**CALIFORNIA COASTAL COMMISSION**

**Item W21d****STAFF REPORT: REGULAR CALENDAR**

APPLICATION NUMBER: 5-01-307

PROJECT DESCRIPTION: Construction of a five-level, 38-foot high (above average grade), 3,942 square foot single family residence on a vacant lagoon-fronting lot.

**COASTAL COMMISSION**  
 5-01-307  
 EXHIBIT # 3  
 PAGE 2 OF 2

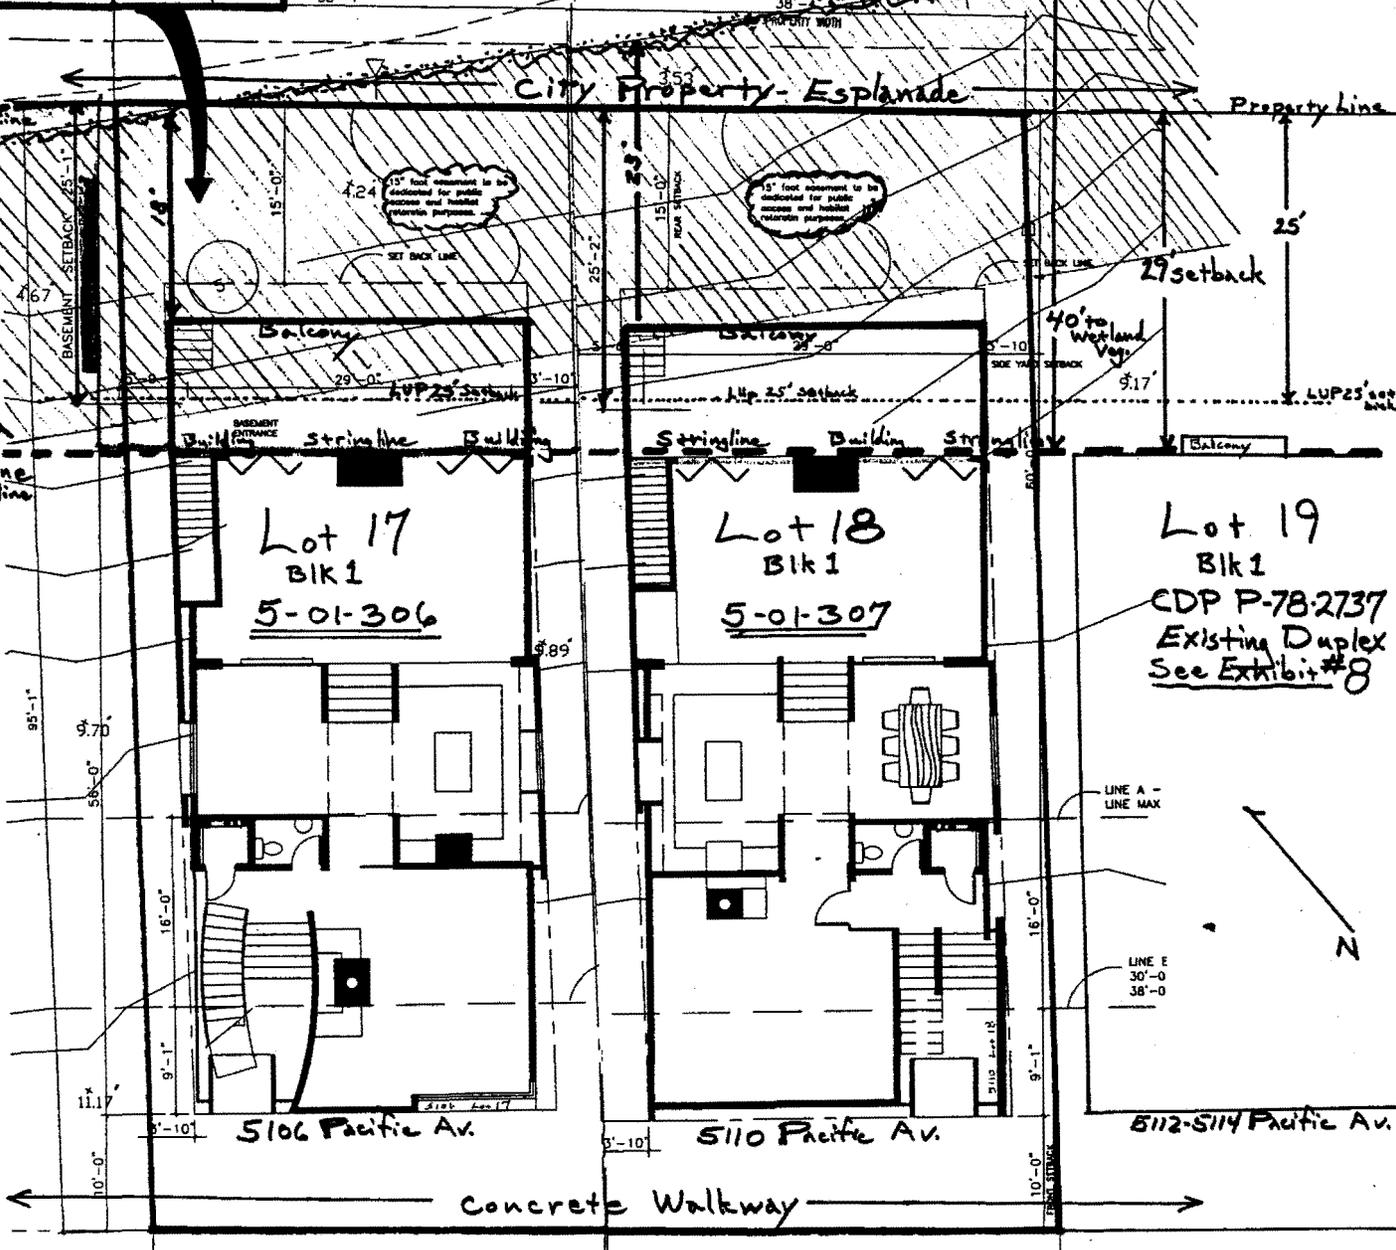
**Staff is recommending that the applicant provide a 25-foot wide protective lagoon buffer strip, measured inland from the high water line** where a strip of wetland vegetation is growing along the shoreline of the lagoon (Exhibit #4). No development would be permitted within the 25-foot wide protective lagoon buffer strip. Additionally, in order to maximize the airspace for the bird flyway and visual cone over the ESHA, and to enforce a stringline for residences on this block (Block 1 of the Del Rey Beach Tract), **staff is recommending that the residential structure (including balconies) be set back at least 29 feet from the eastern (lagoon-side) property line.** A 29-foot structural setback and stringline is consistent with the Commission-approved setback imposed on Lot 19 in 1978 (P-78-2737), the only other existing residence on this block (Exhibits #4&8).

Hatched area is 25' wide buffer between Wetland veg. & development.

A 25-foot wide protective lagoon buffer strip (lagoon buffer), measured from the high water line (elevation +2.65 as shown on **Exhibit #4 of the 1/17/02** staff report), shall be maintained between the approved development and Ballona Lagoon. The 25-foot wide lagoon buffer includes the proposed fifteen-foot (15') wide easement over the entire width of the applicant's property as described in Special Condition Two below. No construction, grading, placement of fill, or other development shall occur within the 25-foot wide lagoon buffer, with the exception of landscaping with plants native to the Ballona Lagoon habitat area (and a public path if approved by the Commission).

EXHIBIT # 5

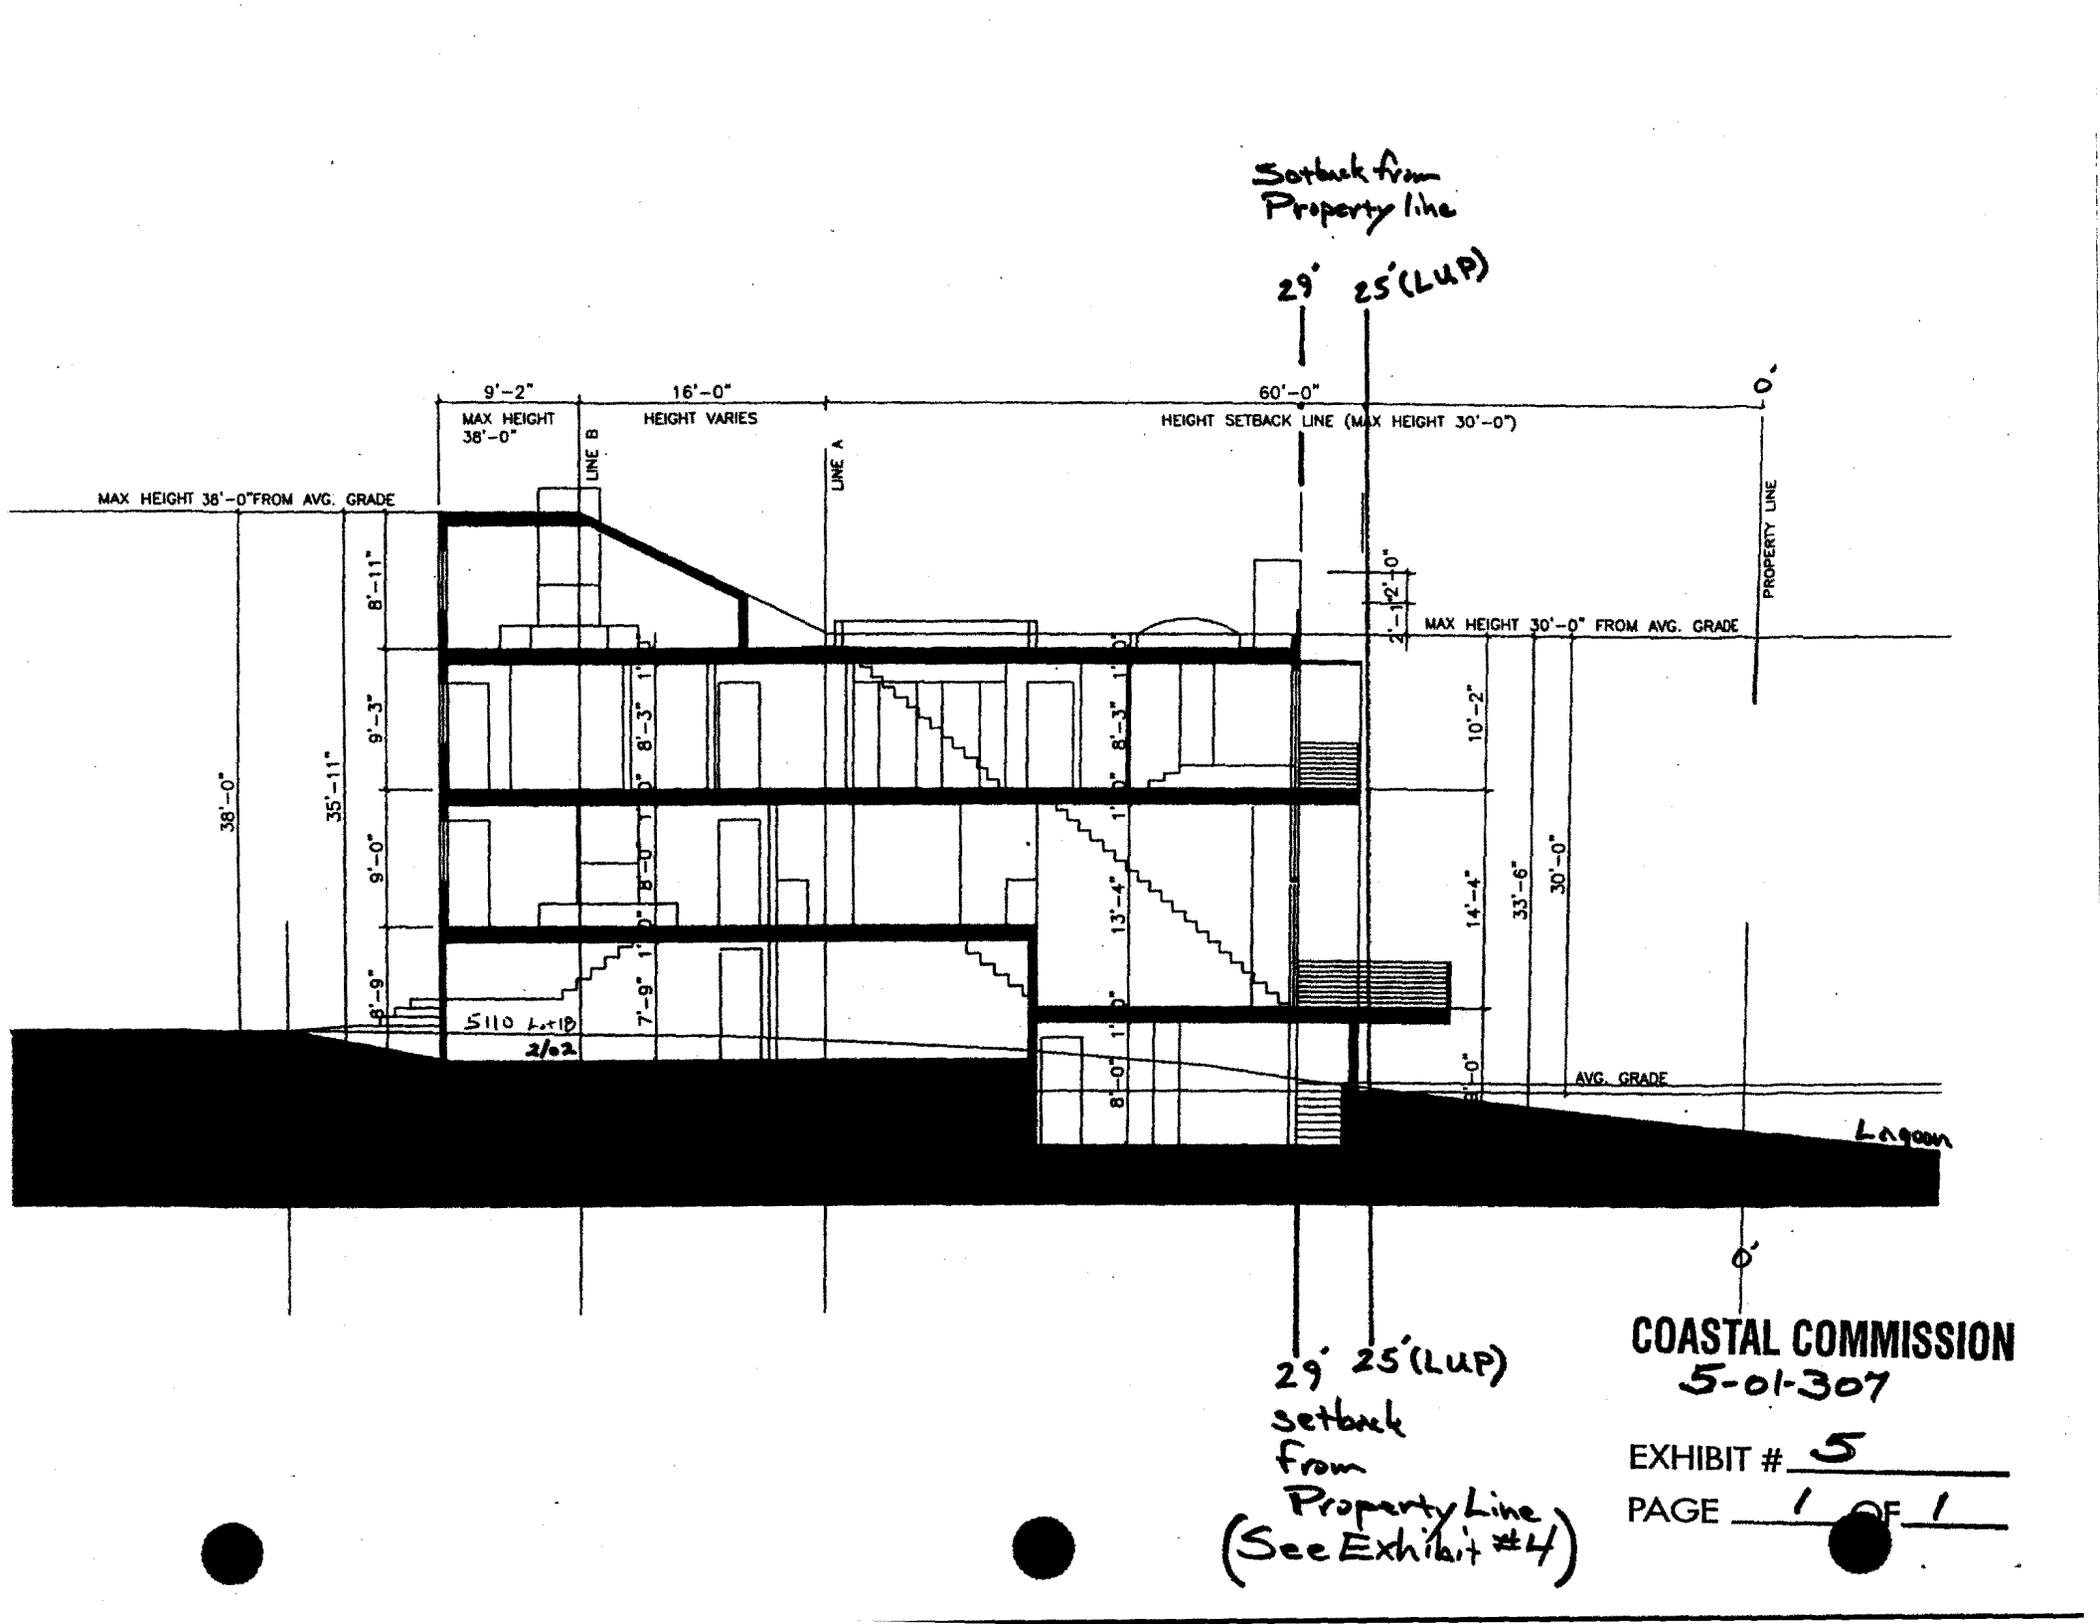
As proposed, a second-level balcony is set back 18 feet from the eastern (lagoon-side) property line. Therefore, the proposed balcony extends within 23 feet of the lagoon's high water line and the inland extent of the lagoon's wetland vegetation. The front of the building, excluding the second and third-level balconies, is situated 29 feet inland of the eastern (lagoon-side) property line (Exhibit #5). The roof of the proposed structure is limited to thirty feet above average grade within sixty horizontal feet of the mean high tide line of Ballona Lagoon, but roof deck railings and other parts of the proposed building would violate the thirty-foot height limit that protects the bird flyway and cone of vision over the ESHA (Exhibit #5).

- (i) **Building Setback.** All portions of the dwelling (including stairways, balconies, and bay windows) shall be set back at least 29 feet from the eastern (lagoon-side) property line. Any area situated between the 25-foot wide protective lagoon buffer strip described in Special Condition One and the 29-foot structural setback may be used only for native landscaping or for an uncovered and permeable deck at ground level (no more than 18" high) and fences and walls not exceeding six feet in height above natural grade. No deck, fence, wall or other accessory structure shall encroach into the lagoon buffer strip described in Special Condition One.
